# Urgent Field Safety Notice Product Correction

**Date Issued** July 28, 2009

Product Name	List Number	Part Number
ARCHITECT i2000 System	8C89 1G17	
ARCHITECT i2000SR System	3M74	
Concentrated Wash Buffer (1 L)	6C54-58	
Concentrated Wash Buffer (10 L)	6C54-88	
Wash Zone Mechanism Grounding Kit		7-201369-01

**Ground strap (cable)**

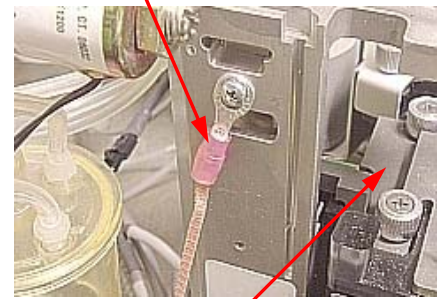
Based on a single customer report and our internal investigation, we have determined that under specific conditions (such as spills, leaks, or improper maintenance) on the ARCHITECT i2000 or i2000SR Systems, the concentrated wash buffer (containing sodium azide) can come in contact with the wash zone mechanism ground straps (cables) on either of the two wash zones. The copper in the ground strap may corrode and form an unstable chemical substance (metal azide) that may be sensitive to direct pressure and impact.

Ground straps that are covered with residual solids and/or show other signs of chemical effects may react to impact or other pressure, possibly resulting in a popping noise and release of particulates from the cables. Please follow your laboratory procedures related to use of personal protective equipment (safety glasses, lab coat, gloves, etc.).

When performing weekly maintenance procedure 6015 WZ Probe Cleaning – Manual, observe the condition of the ground strap. If there is corrosion on the cable, **DO NOT TOUCH IT**. Contact Abbott immediately.
